APPLICATION NO.	FILING DATE	FIRST NAMED INVENTOR	ATTORNEY DOCKET NO.	CONFIRMATION NO.
10/599,855	10/11/2006	Navin N. Thakkar	TKKR-002	5789
26392	7590	04/15/2008	EXAMINER	
LAW FIRM OF NAREN THAPPETA C/O LANDON IP, INC. 1700 DIAGONAL ROAD, SUITE 450 ALEXANDRIA, VA 22314			MERENE, JAN CHRISTOP L	
		ART UNIT	PAPER NUMBER	
		3733		
		MAIL DATE		DELIVERY MODE
		04/15/2008		PAPER

Office Action Summary	Application No.	Applicant(s)
	10/599,855	THAKKAR, NAVIN N.
	Examiner	Art Unit
	JAN CHRISTOPHER MERENE	3733

DETAILED ACTION

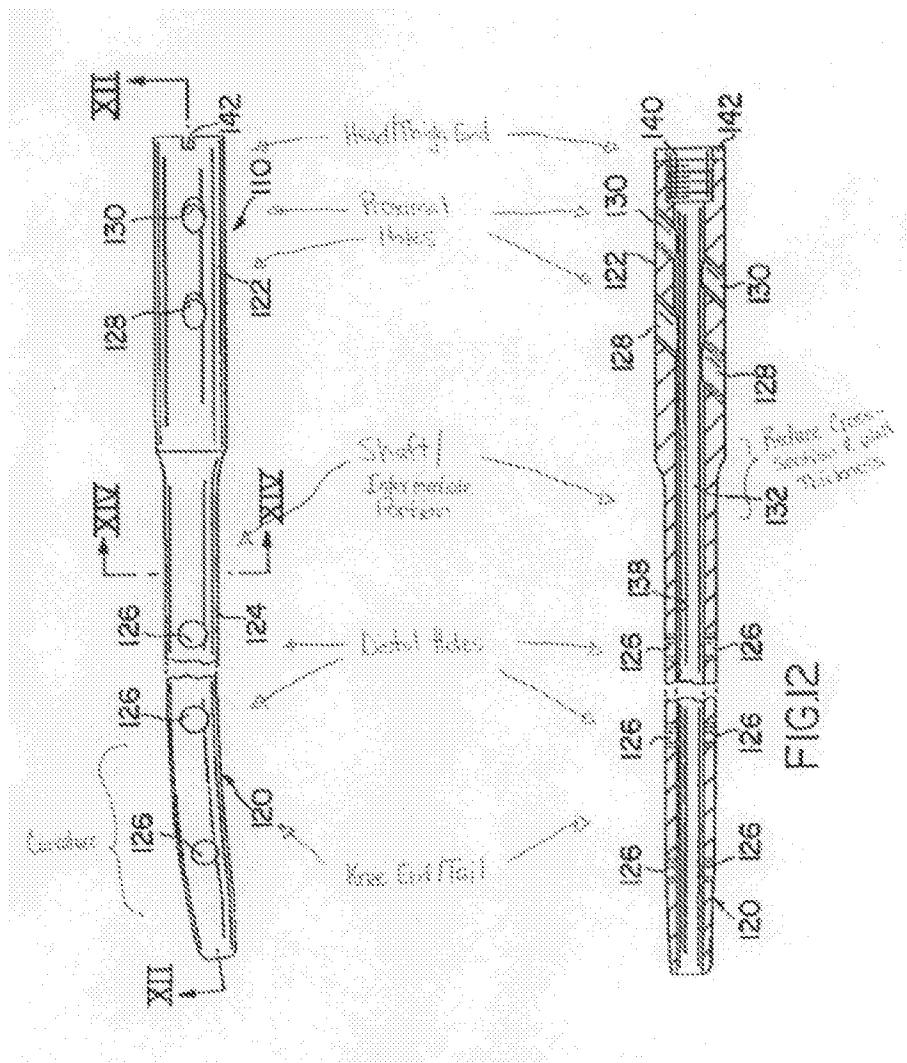
a compact targeting device (see Fig 1 and 4 below) having connecting end (#56) to connect with thigh end (#14) of intramedullary nail (#12) by temporary connecting bolt (#50), a handle part (#56), block of plural proximal holes (#26) and block of plural distal holes (#30).

However, Crickenberger et al discloses a similar device with a cannulated connecting bolt (#77), a targeting device (#41) and a cannulated intramedullary nail

(#13). It would have been obvious to one having ordinary skill in the art to modify the connecting bolt/end cap (#50) and intramedullary nail (#12) of Zirkle, JR to be cannulated because it provides internal access to an intramedullary nail for placement of an element such as a wire (see abstract and see Col 4 lines 48-51, where #77 has aperture #83 and Fig 3). It would have also been obvious to one having ordinary skill in the art to provide an intramedullary nail of short length and full length version to accommodate patients's of different sizes. Crickenberger et al discloses the device may include a plurality of assembled targeting devices/stems of different sizes, neck angles, etc. (see Col 5 lines 16-20).

Short Version:

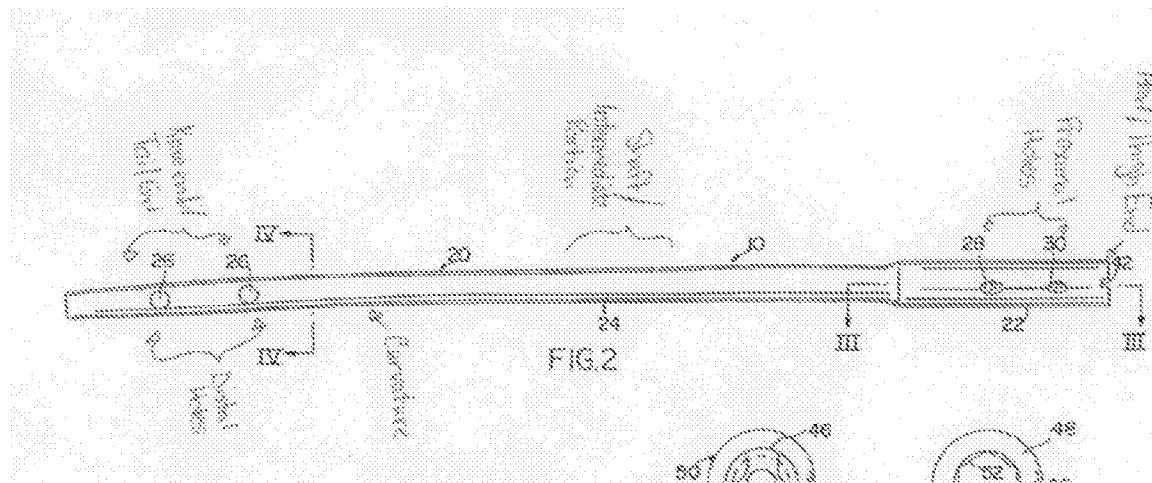
Brumfield discloses a unitary intramedullary nail of short length version (#110 as seen in Figs 1A, 11-12) and full length version (#10 as seen in Figs 1-2) being adapted in use for insertion into the medullary canal of a femur, is cannulated in whole length (as seen in figs 3-4 for #10 and Fig. 12 for #110), having thigh end portion or head, intermediate portion or shaft and knee end portion or tail , where said shaft is having plural distal holes to hold distal fragment of femur in said short length version and said knee end is having anterior curvature, and plural distal holes in said full length version and axis of said distal holes is making an angle of 90° with longitudinal axis of medullary

canal and said intramedullary nail when said intramedullary nail is in position in medullary canal (as seen in Fig 1, where #10 has proximal holes oriented at 90 degrees with respect to the femur and see Figs below);

Zirkle, JR

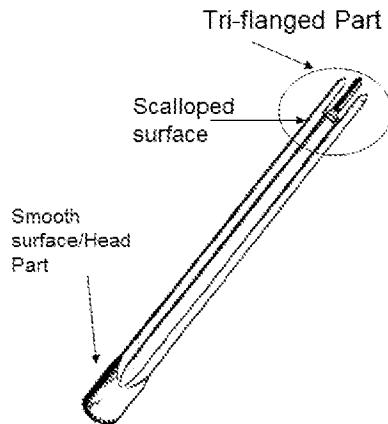
However, Vestby discloses a hip pin (as seen in Fig 1) is cannulated in whole length (see Col 1 lines 61-62, where the nail has a hollow body) and a triflanged part, where said triflanged part is has scalloped three flat equal surfaces (see Fig 1 below and).

It would have been obvious to one having ordinary skill in the art to modify the hip pin (#100) of Zirkle, JR with the cannulated body and triflanged part (as seen in Fig 1) of Vestby because a cannulated nail can be used with a guide wire (see col 1 lines 1619) and the triflanged part is one of many ways one of ordinary skill in the art would try to fixate a pin/nail/screw onto the bone (see Col 1 lines 65-67 in Vestby).

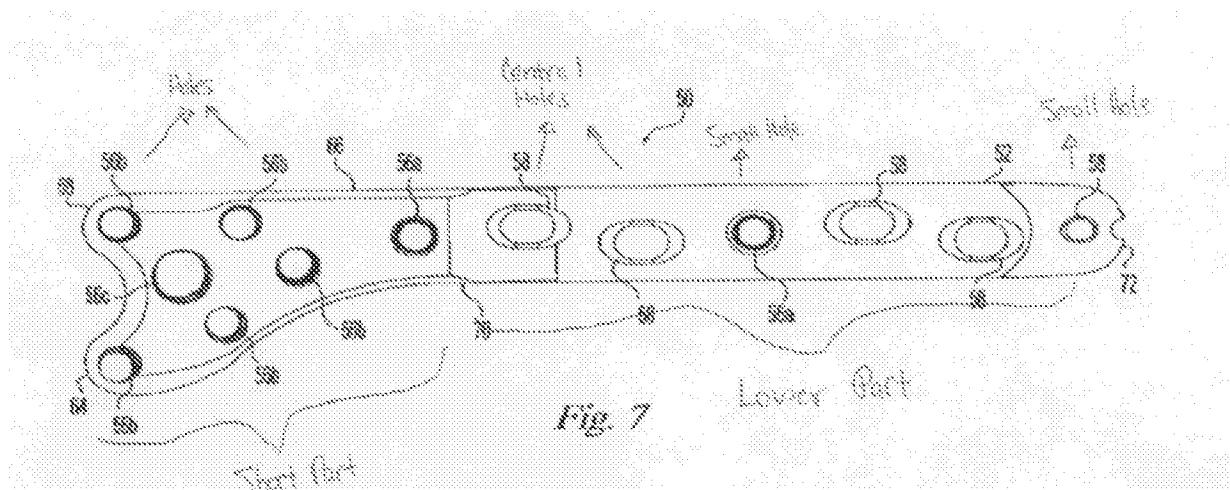
Zirkle, JR does not also disclose a buttress plate. However it would have been obvious to one having ordinary skill in the art to use a buttress plate because plates are widely known in the art and used in dealing with bone fractures as taught by Weaver (see abstract).

Weaver discloses a buttress plate (#50 as seen in Fig 7) with holes (as seen in Fig 7 below and further recited in Claim 22). The examiner notes that any of the holes can constitute as a barrel.
